RE: Biological Mitigation Proposal ("Mitigated Ivanpah 3")
Ivanpah Solar Electric Generating System (07-AFC-5)

Biological Mitigation Proposal ("Mitigated Ivanpah 3")

Submitted to the
Bureau of Land Management and the
California Energy Commission

Figure 3-2
Rare Plant Direct Impact Avoidance Areas
 Ivanpah Solar Electric Generating System

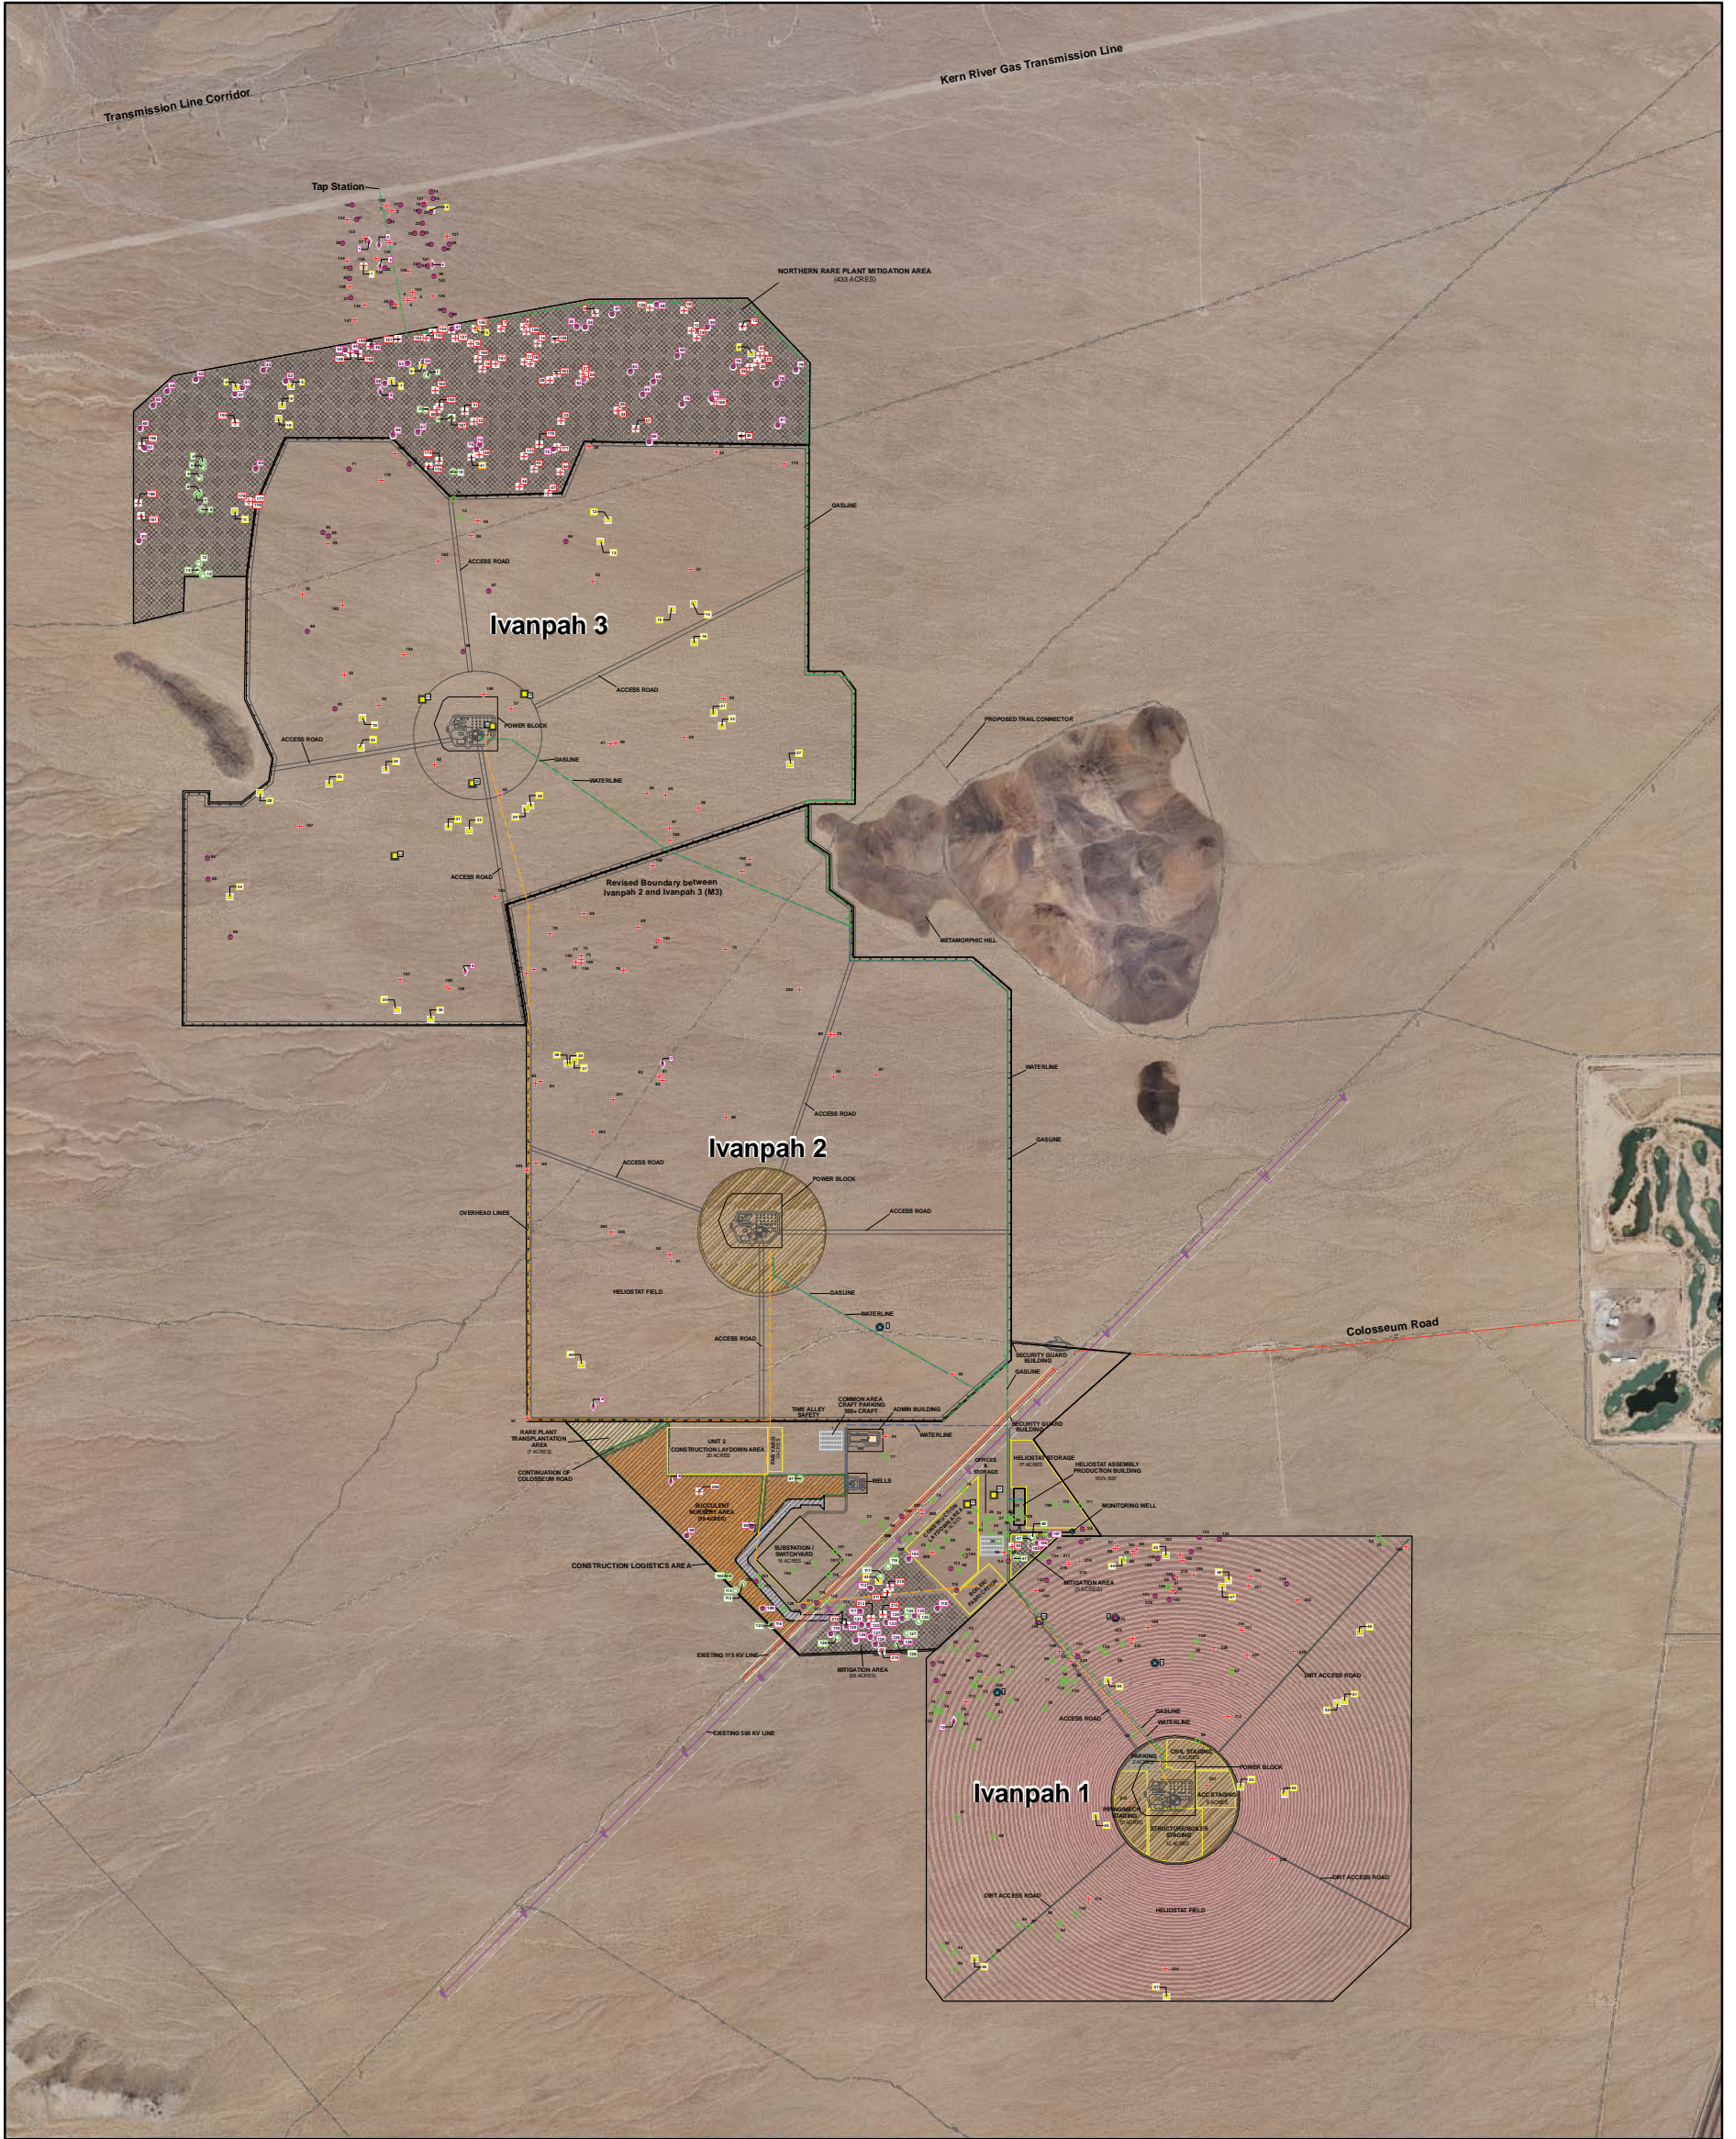
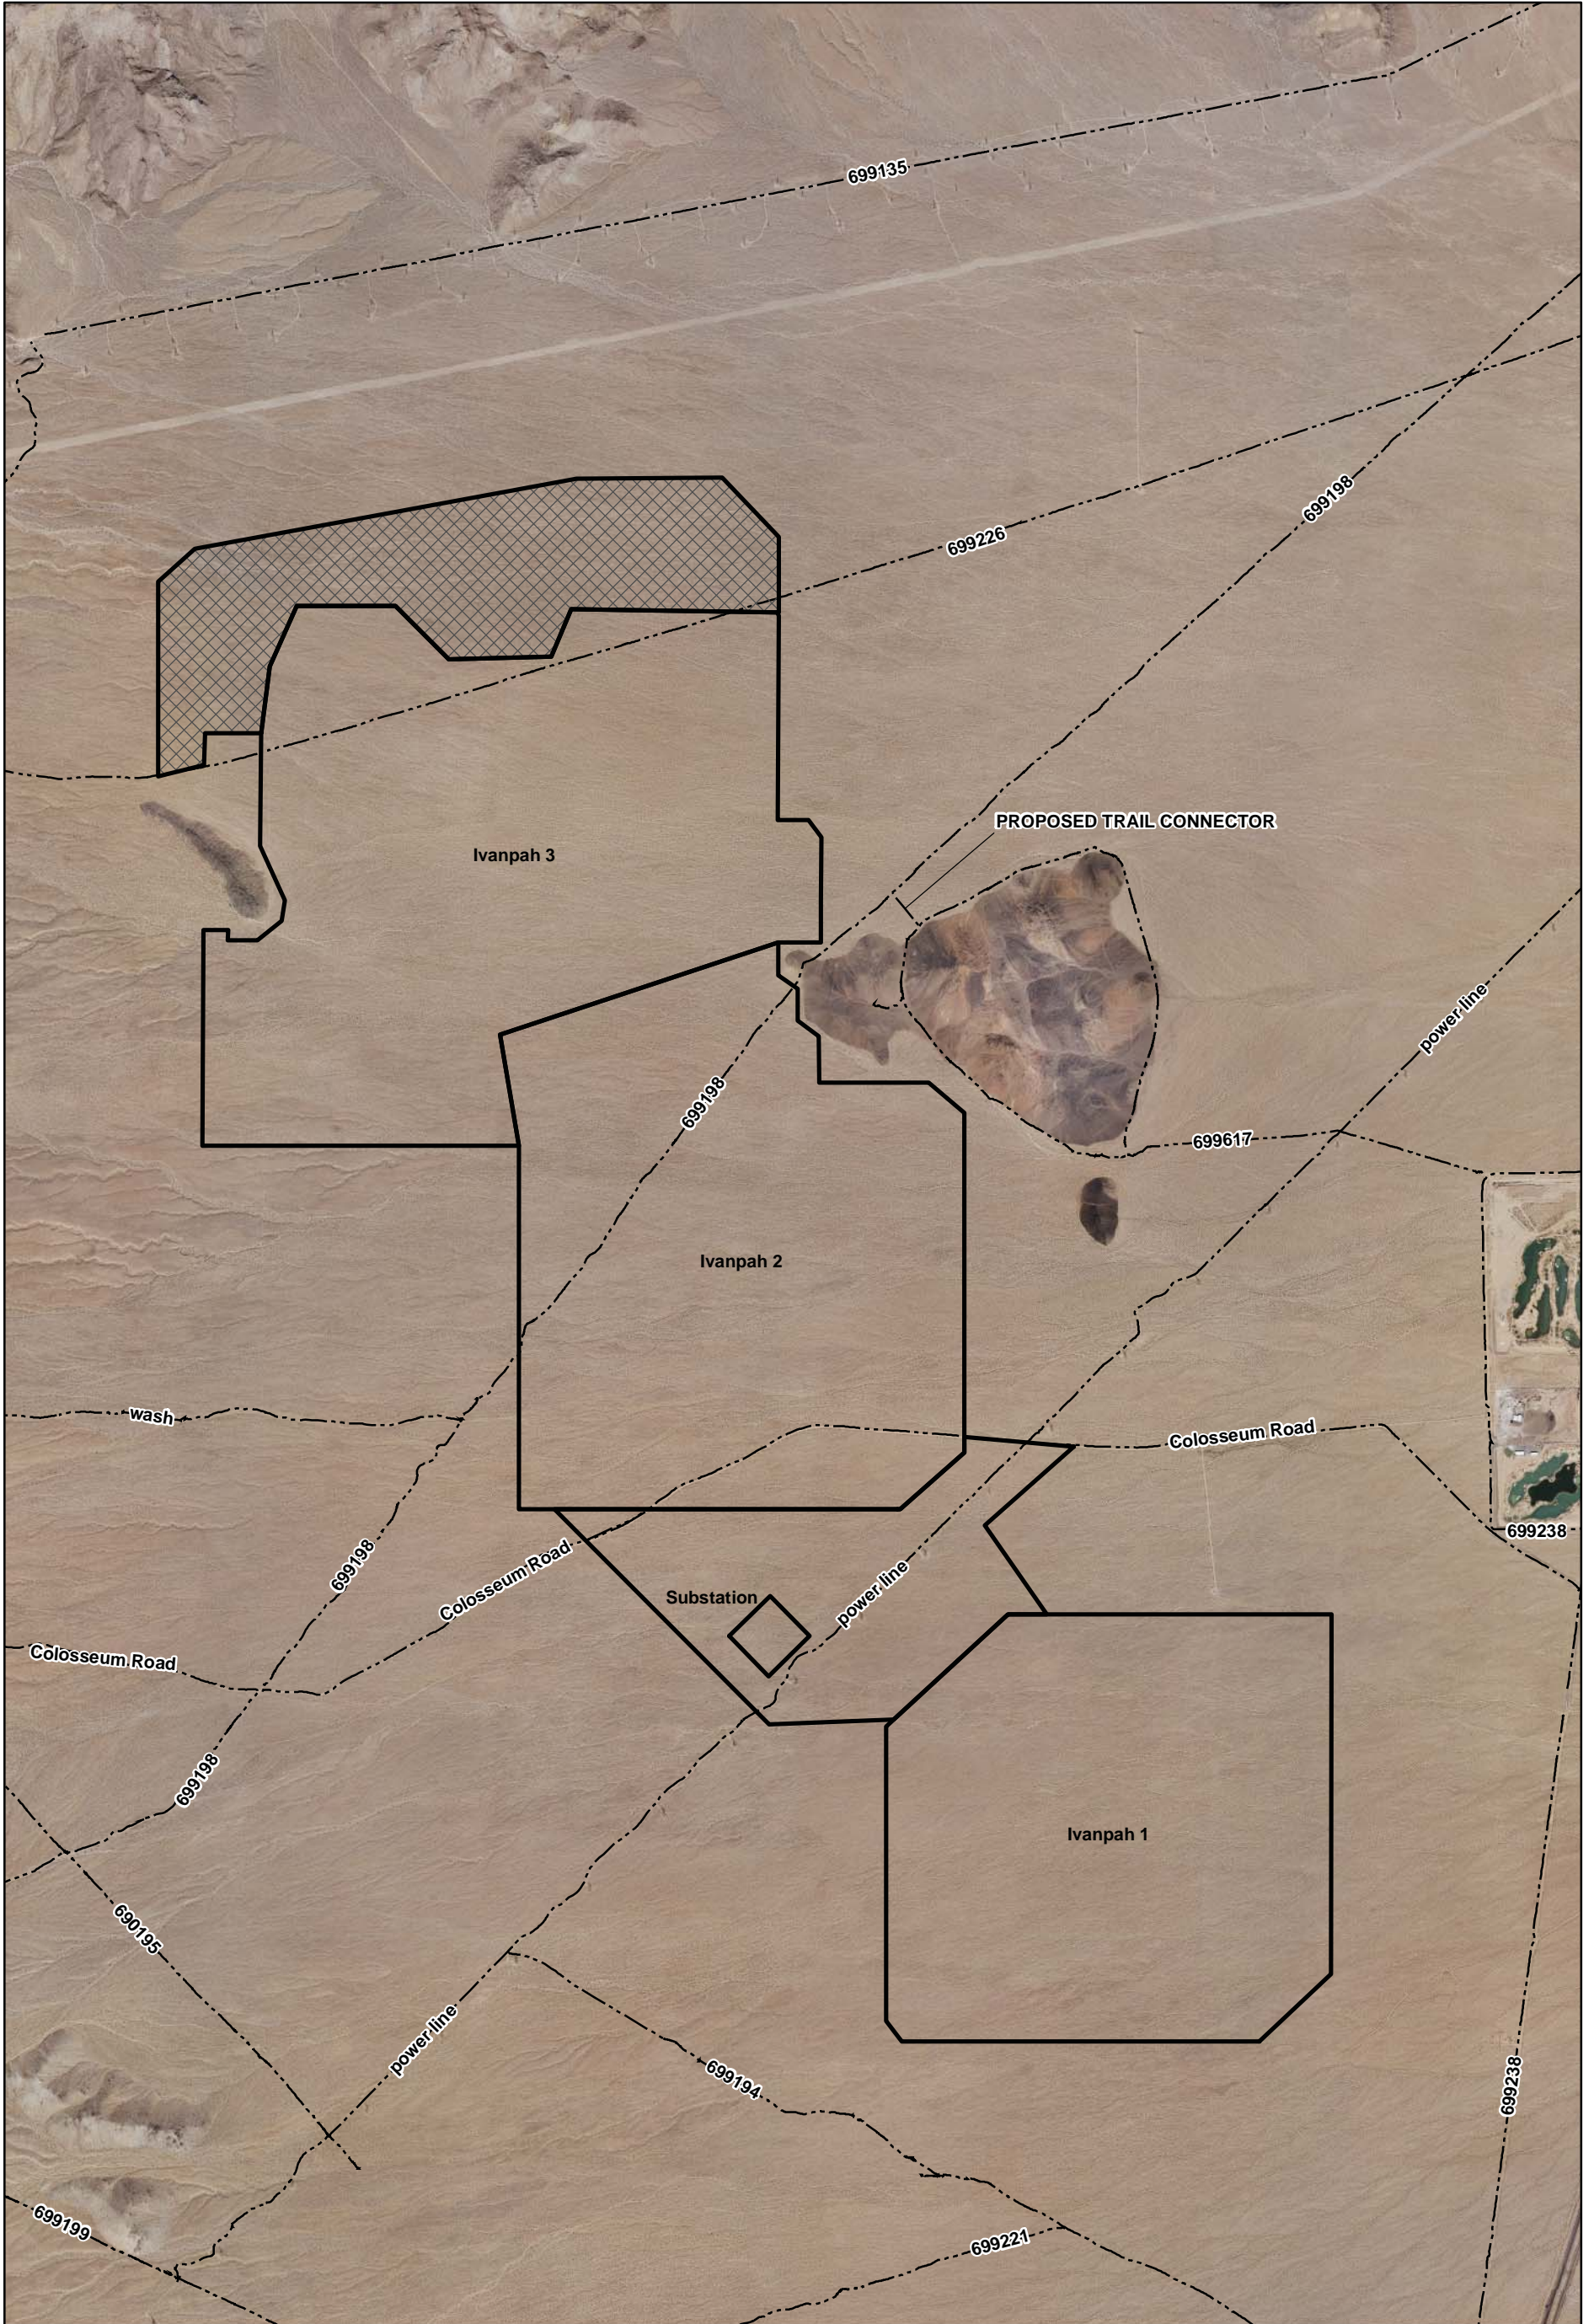
The Mitigated Ivanpah 3 arrangement would result in the establishment of three rare plant mitigation areas located in two general areas onsite (Figure 3-2), in addition to establishing several smaller avoidance areas for two of the six rare plants for which mitigation is recommended by Staff. The rare plant mitigation approach proposed for the Mitigated Ivanpah 3 configuration is consistent with the general rare plant avoidance measures described in the FSA/DEIS and as depicted in FSA/DEIS Biological Resources Figure 2.

In addition to, and not included in the acreage total, are several smaller rare plant avoidance areas for two species, Mojave milkweed and Rusby's desert mallow.⁴ The locations of these smaller avoidance areas are shown on Figure 3-2. These smaller avoidance locations are the same areas as presented in the Ivanpah SEGS Special-Status Plant Avoidance and Protection Plan [Exhibit 81]. They have been selected to avoid and protect 100 percent of the Rusby's desert mallow and the Mojave milkweed areas with the highest densities of plants to the maximum extent practicable while achieving energy generation objectives.

Rare plant localities designated as salvaged on Figure 3-2 (for example, the Mojave milkweed localities that are in an area to be graded) will be removed and transported to the Rare Plant Transplantation Area or other location with similar micro-habitat conditions.
